Memorandum

Subject: Public Works Review 1
East Lake Sammamish Trail Master Plan
Inglewood Hill Road Parking Lot
Shoreline Substantial Development Permit
SSDP2016-00414

Civil Engineering Drawings

Exhibit 39
SSDP2016-00414
001814 SP1

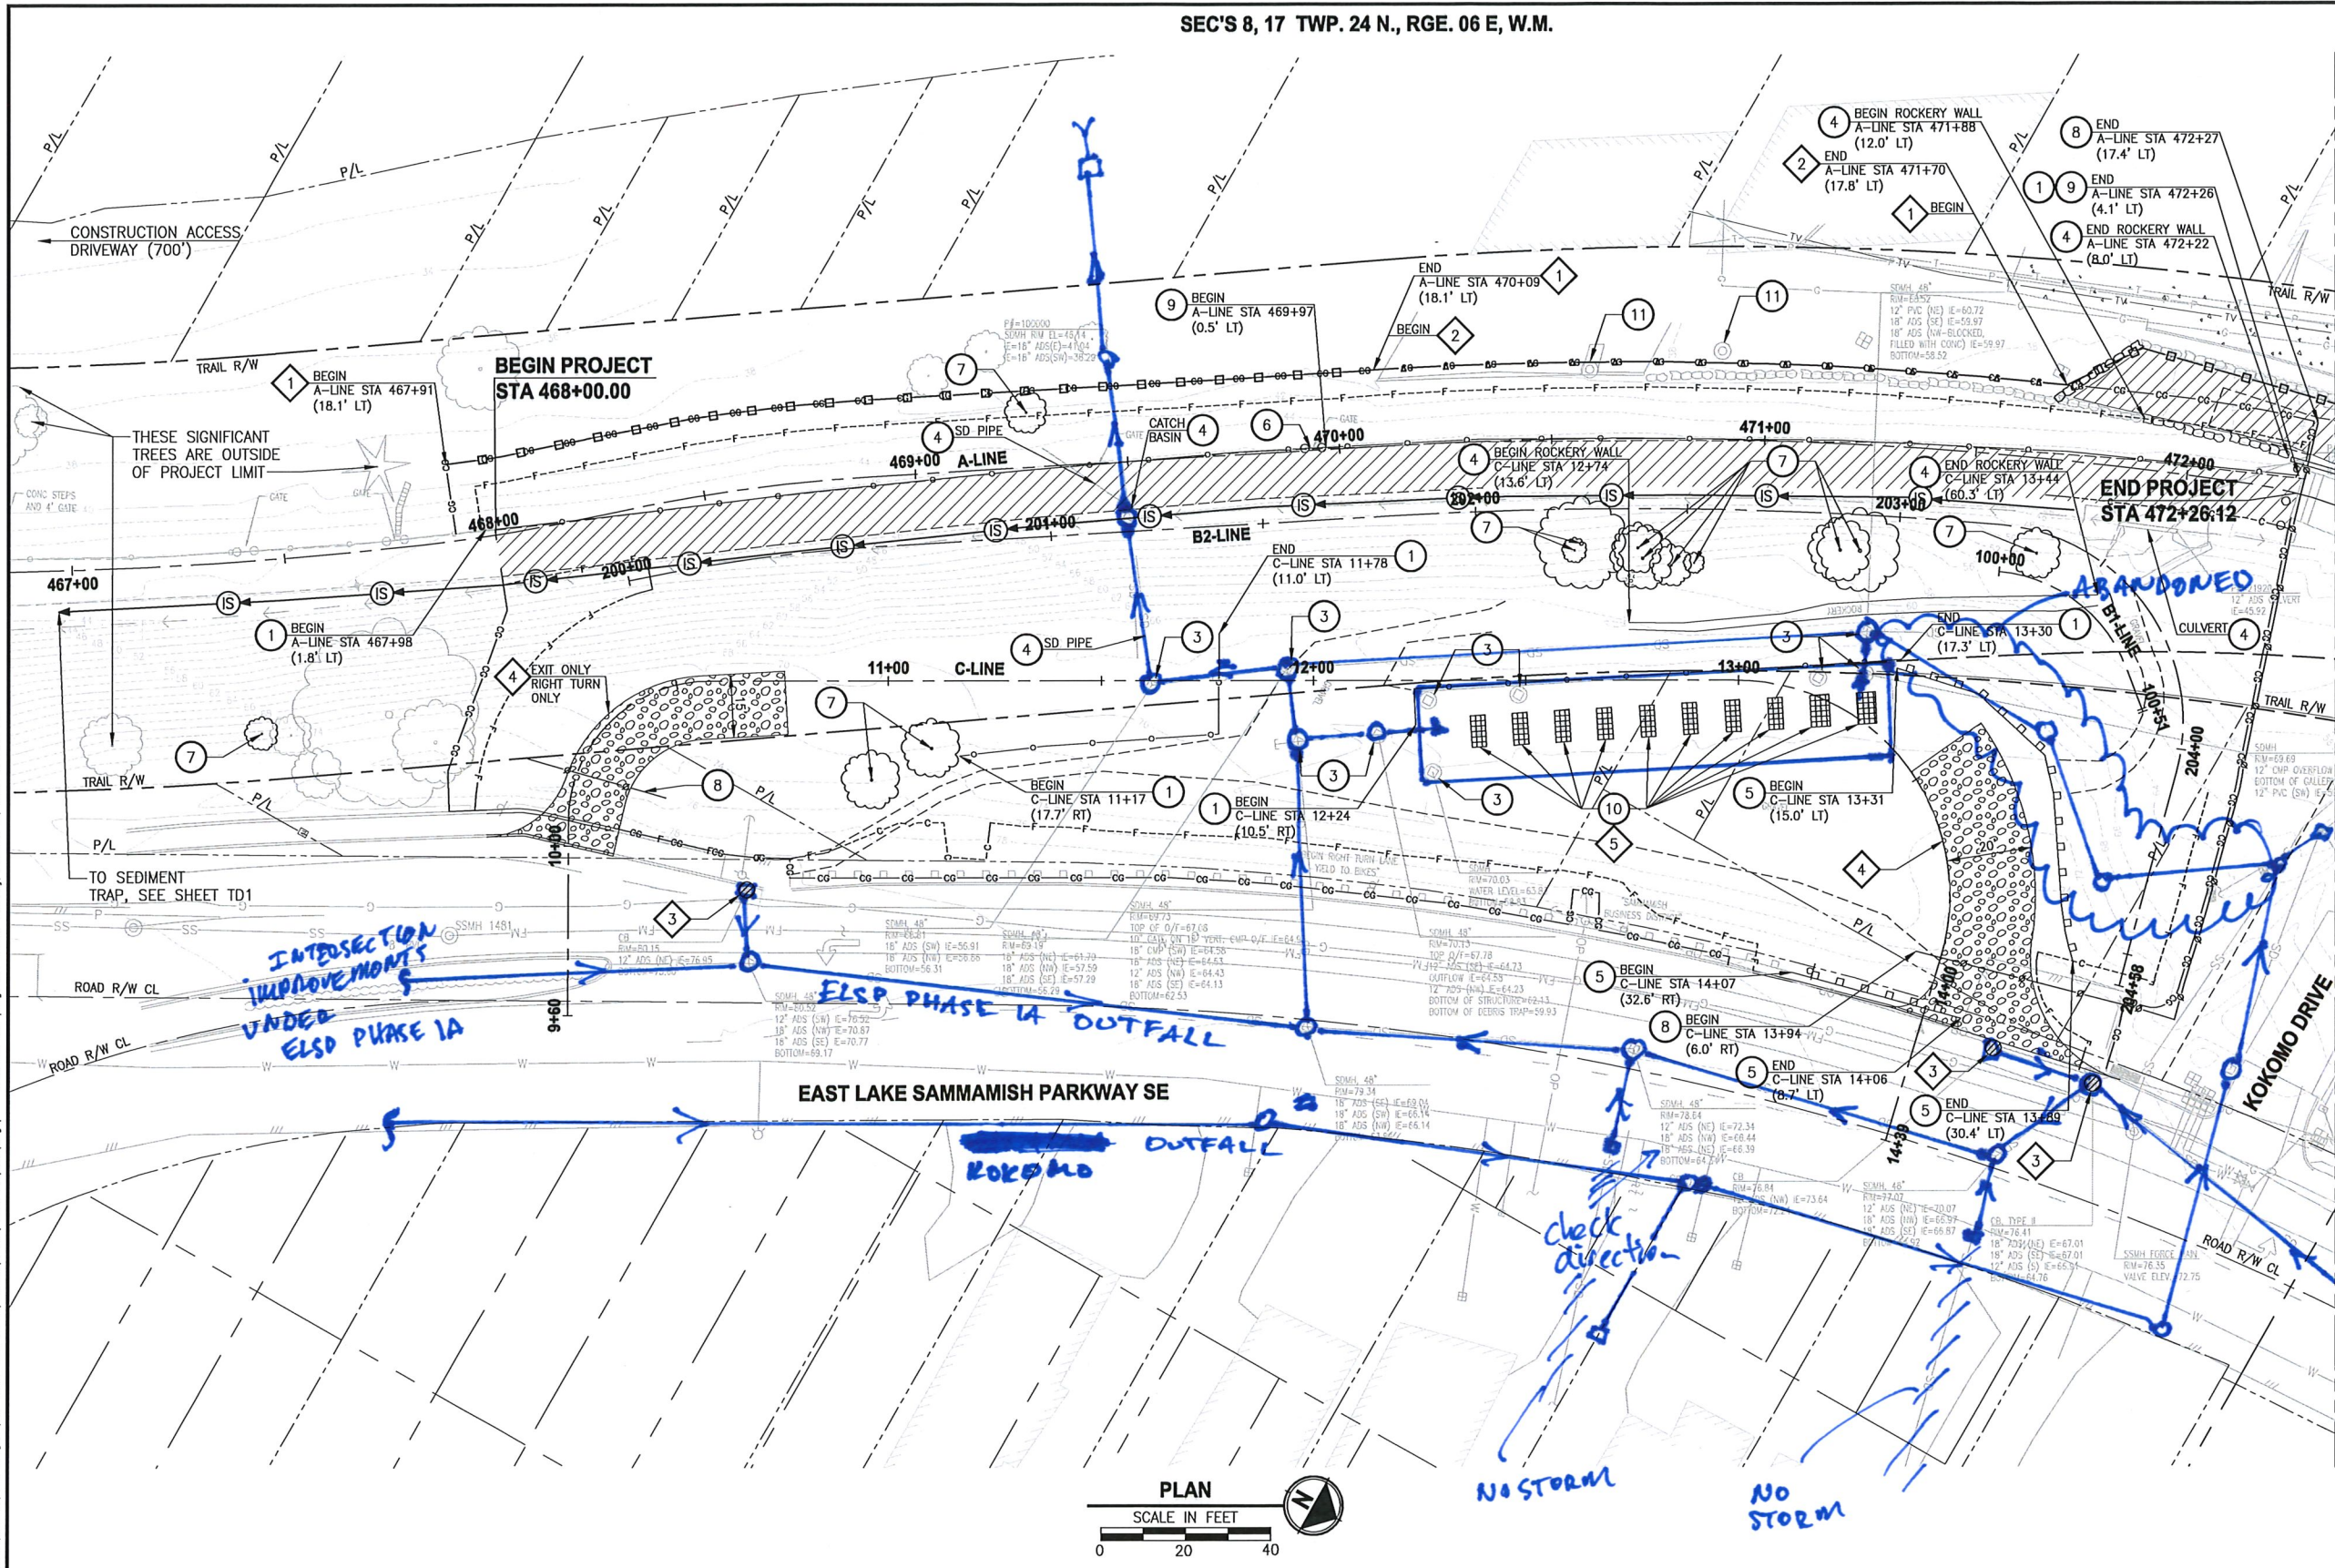
9. Review, revise, and accurately show existing storm drain system on ELSP and through proposed development. See attached markup.
10. Show inlet protection for all existing catch basin along ELSP adjacent to development and through proposed development.

11. Show protection of existing sand filter open grates for erosion and sediment control.
12. Show protection of existing storm system given proposed work.

13. Location of construction access driveway along trail is unclear. Please clarify.
14. Location of sediment trap is unclear. Please clarify.
15. Several significant trees are shown to west and south of clearing limits. Please specify removal or tree protection. If possible, relocate clearing limits to save significant trees.

16. The existing contours and existing storm infrastructure leaders are too light and difficult to see in the plans provided (half-size). Show darker on these plans for clarity.

17. Plans show removal of existing guardrail in the public ROW. Please contact Dan Johnson at City MOC to determine if salvage desired by City.
18. Remove proposed rockery from this plan sheet.

19. Show construction signage to include No Driveway Blocking on Kokomo Drive.
20. Retain existing sidewalk under proposed construction entrance on ELSP. Show wedged curb.

21. Show location of staging area, including job shack, over excavation and material stockpiling, and materials import.
